MINOR PROJECT MODIFICATION

SAN FRANCISCO PUBLIC UTILITIES COMMISSION

Minor Project Modification Number:	03	Date:	1/21/15
Project Title:	CCSF Auxiliary Water Supply System Seismic Upgrade Project		
MEA Case No./Project No.	2009.0568E/CUWAWSAW04		
MPM Prepared By:	Scott MacPherson, Environmental Project Manager		
MPM Triggered By:	<input type="checkbox"/> RFD	<input type="checkbox"/> PCO	<input checked="" type="checkbox"/> Other: SFPUC
Landowner:	<input checked="" type="checkbox"/> SFPUC	<input type="checkbox"/> Other:	
Vegetative Cover/Land Use:	Lawn, existing building	Net Acreage Affected:	.34 acres (w/o building)
Modification From:	<input type="checkbox"/> Mitigation Measure:	<input checked="" type="checkbox"/> Other:	Project Description
	<input type="checkbox"/> Permit:

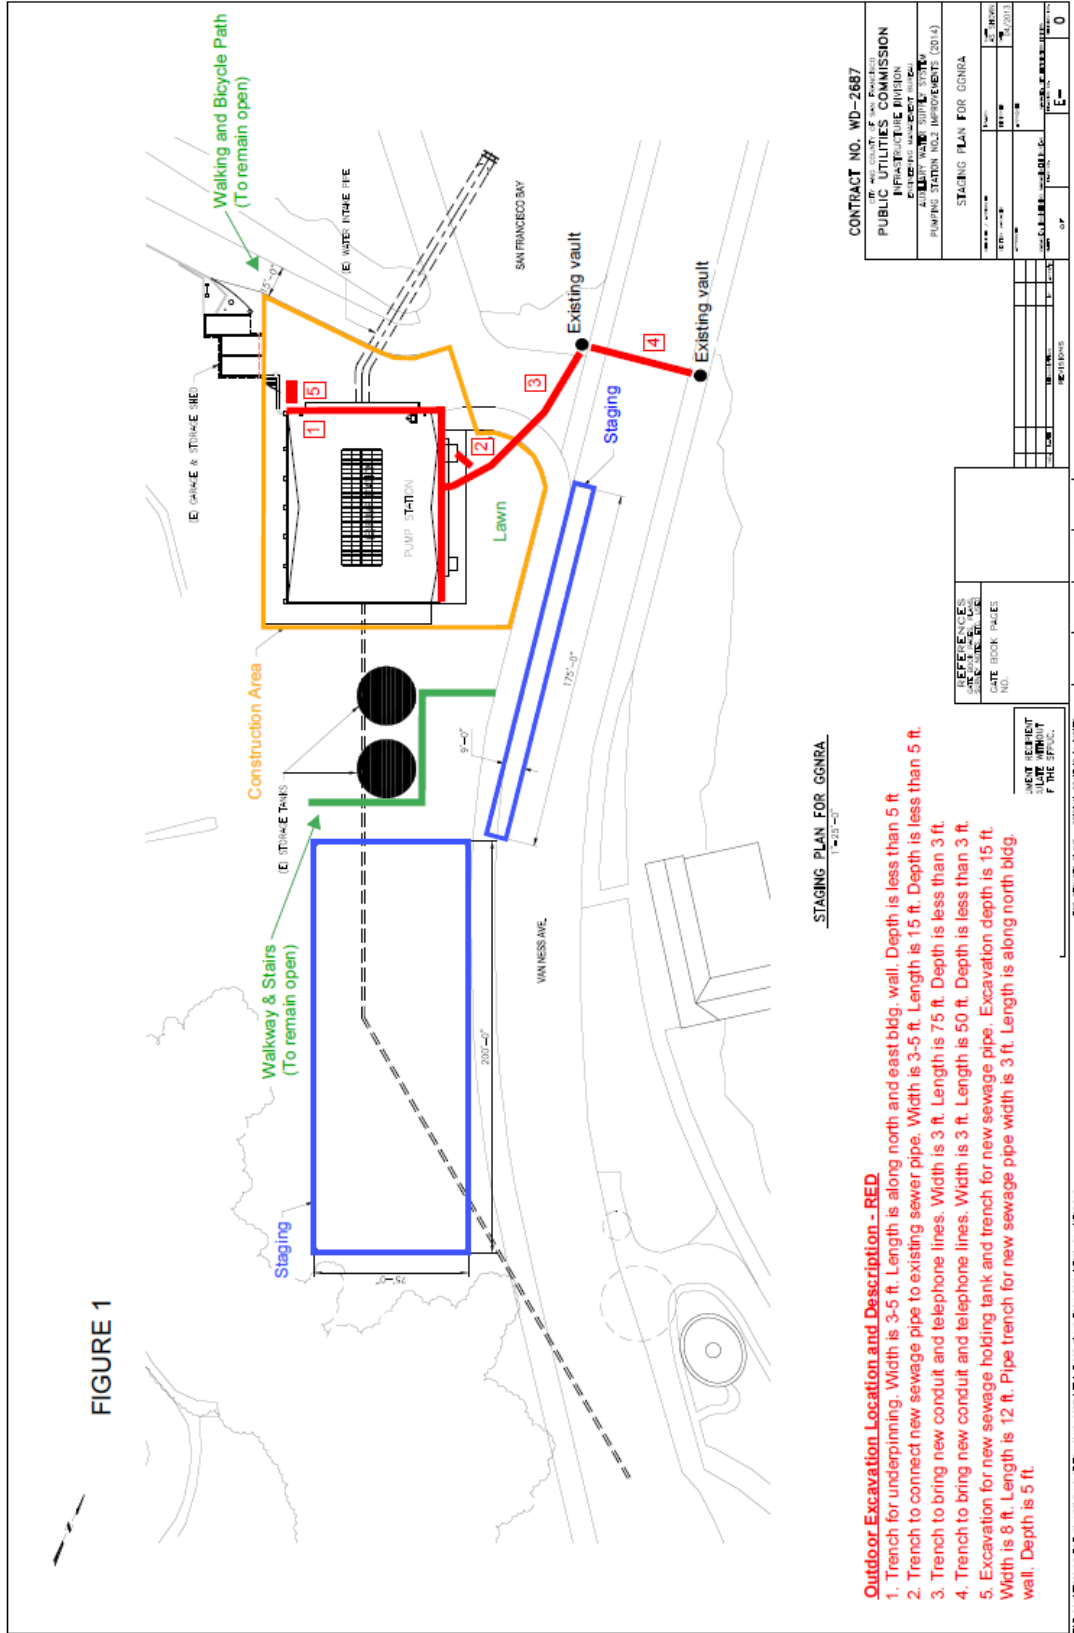
After the FMND was approved, further design work for PS 2 (to meet seismic safety criteria) resulted in changes in the preliminary design as described in the FMND. A new site plan is shown in Figure 1.

FIGURE 5 - Piping above boiler.

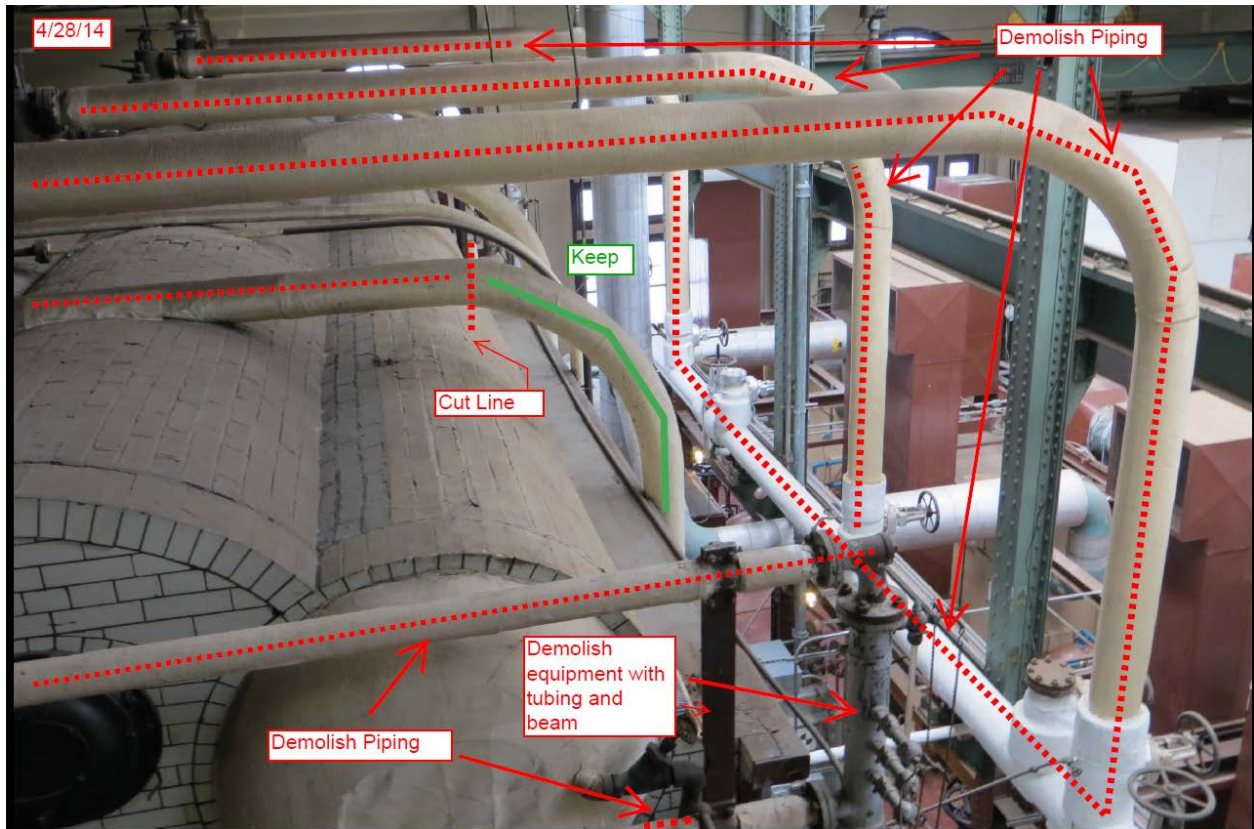
Piping—The piping attached to the existing boiler facades, heaters, and one of the feedwater pumps would be seismically braced and remain in their current configuration. The piping interconnecting the boilers and the other feedwater pumps would be demolished. The piping along the north elevation would

be demolished, but most pipes along the south elevation would remain in place. The existing boiler piping and locations where boiler piping would be removed is shown in Figures 3-6.

FIGURE 9 - Electrical panel as seen from mezzanine stairs.

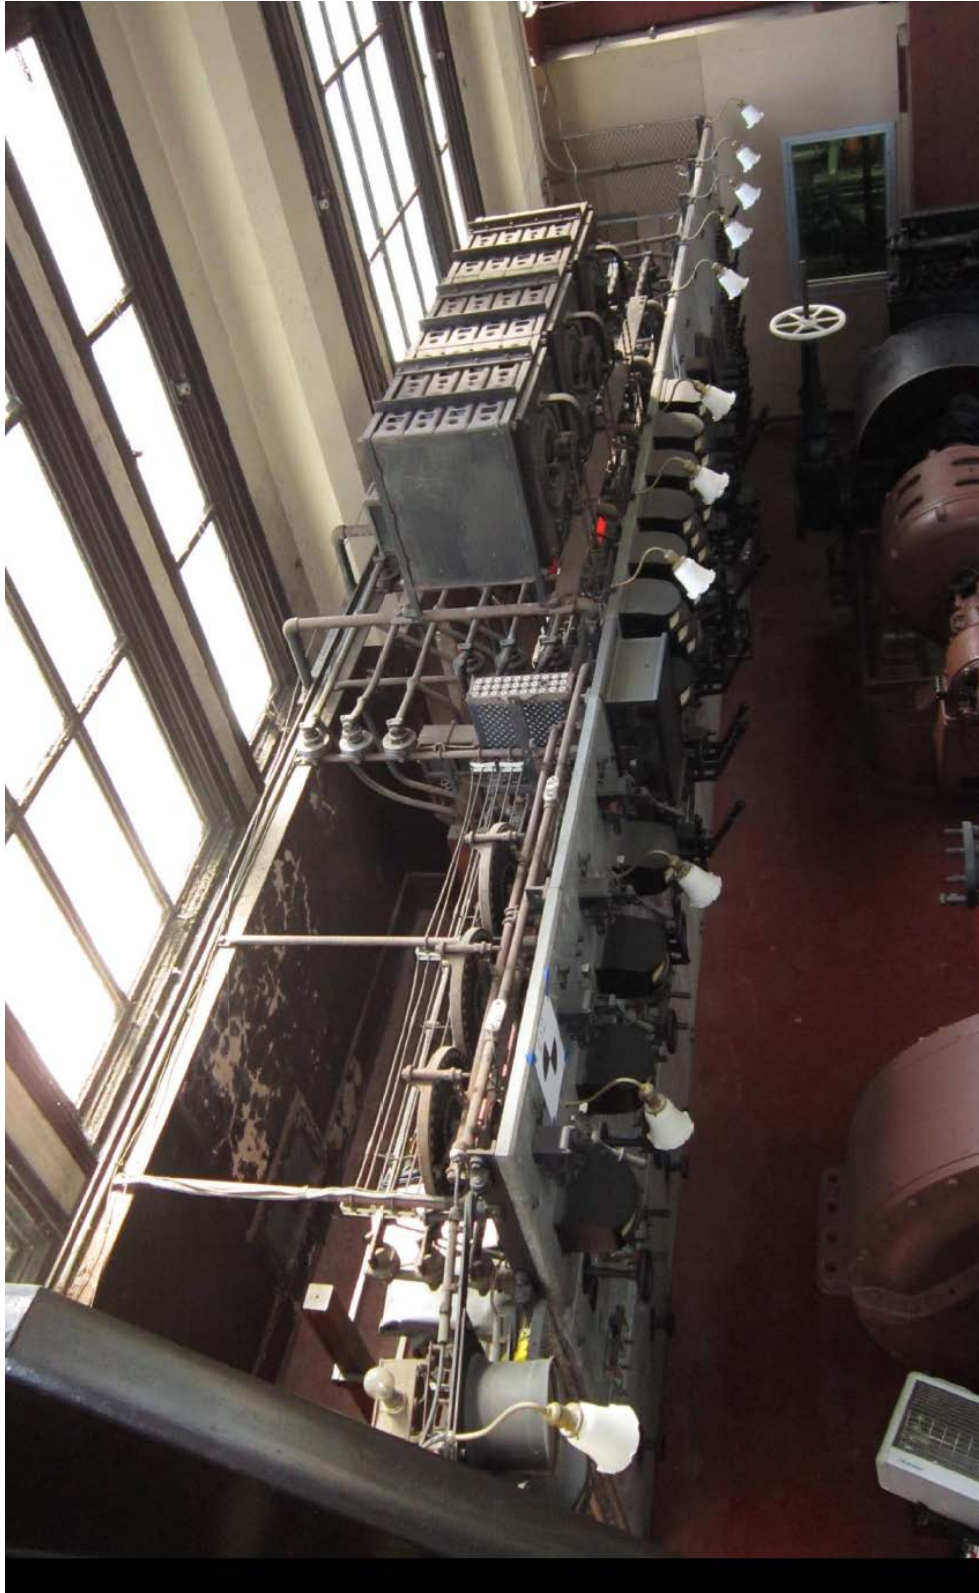
Electrical Panel—The original electrical panel (Figure 9) requires seismic bracing, which requires the removal of equipment behind the panel. The proposed electrical panel support framing plan is shown in Figure 10. Any historically significant equipment behind or above the panel that can be salvaged during construction would be displayed behind the boiler facades. Alternatively, some of the equipment (such as the three large “boxes” on top of the panel) could be displayed in front of the electrical panel. A synchronizer indicator to the north of the panel (Figure 11) would be relocated to the adjacent new office wall. A historic monitor would be present during this equipment removal to determine what can be salvaged and to provide direction on minimizing damage.

FIGURE 16 - Basement air pump

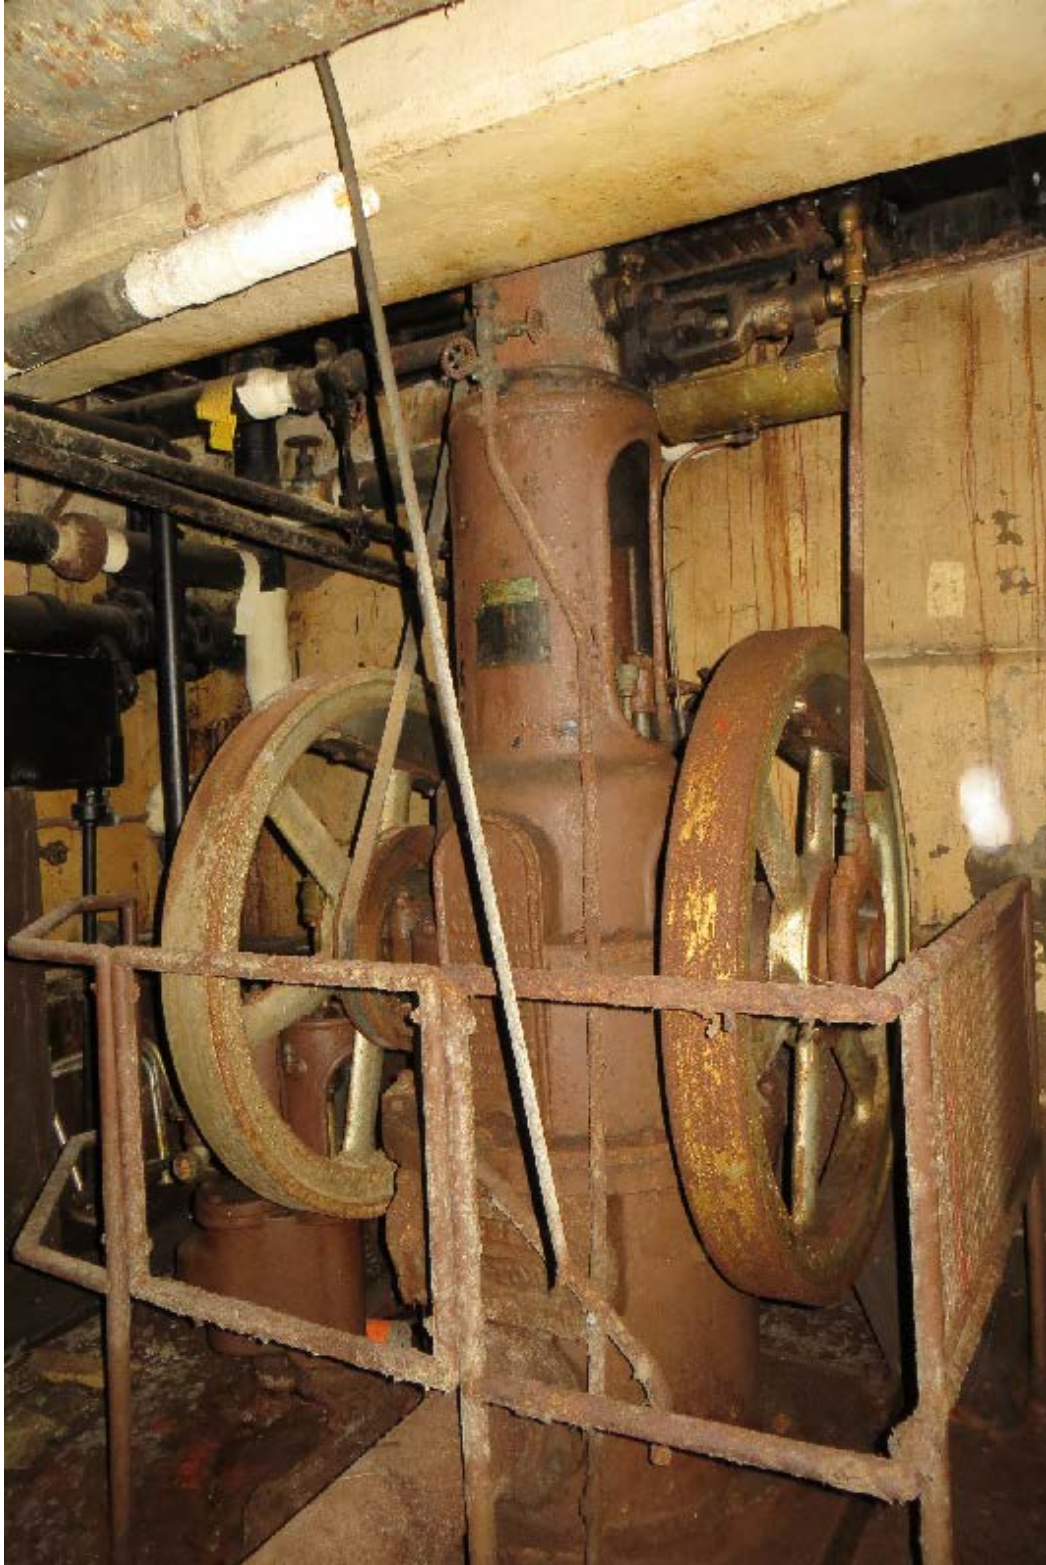
Basement—The basement would be backfilled and covered with a concrete slab, in order to strengthen the foundation and avoid a structural void. The existing (and unused) equipment in the basement (Figures 15-17) would be relocated behind the boiler facades in a similar alignment.

FIGURE 21 - Northern door showing proposed ADA automatic door equipment.

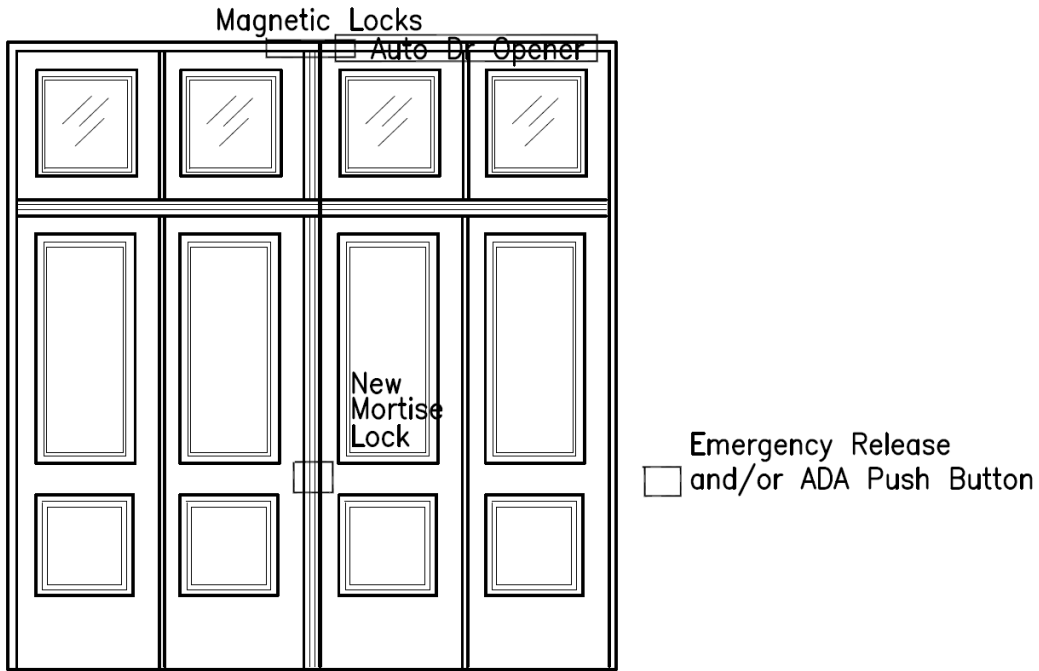
Main Door—The main (north) door to the facility would include a new lock, an automatic door opener, and push button to meet ADA access requirements (Figure 21).

FIGURE 25 – Location of the new disconnect switches on northern façade of building.

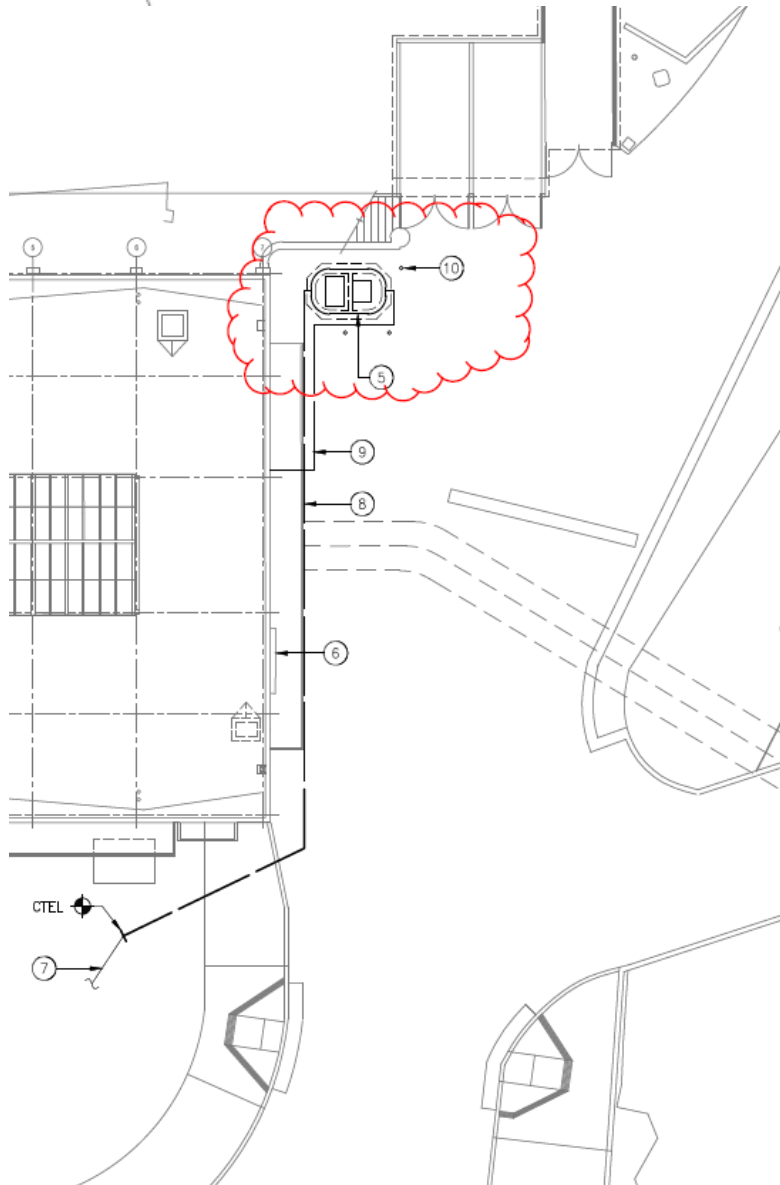
There are two small disconnect switches located in a vault in front northeast corner of the building for the existing sewage holding tank, which will be removed (Figure 24). Due to code requirements, these switches need to be relocated above ground in view of the tank. New disconnect switches would be mounted on the exterior north wall of the Pump Station near the new holding tank, at approximately 48 inches above ground (see Figure 25). A 4-inch pipe would extend up from the ground approximately 3 feet over the new holding tank (currently the site of a parking space), protected by bollards. Figure 26 indicates the position of the bollards in red.
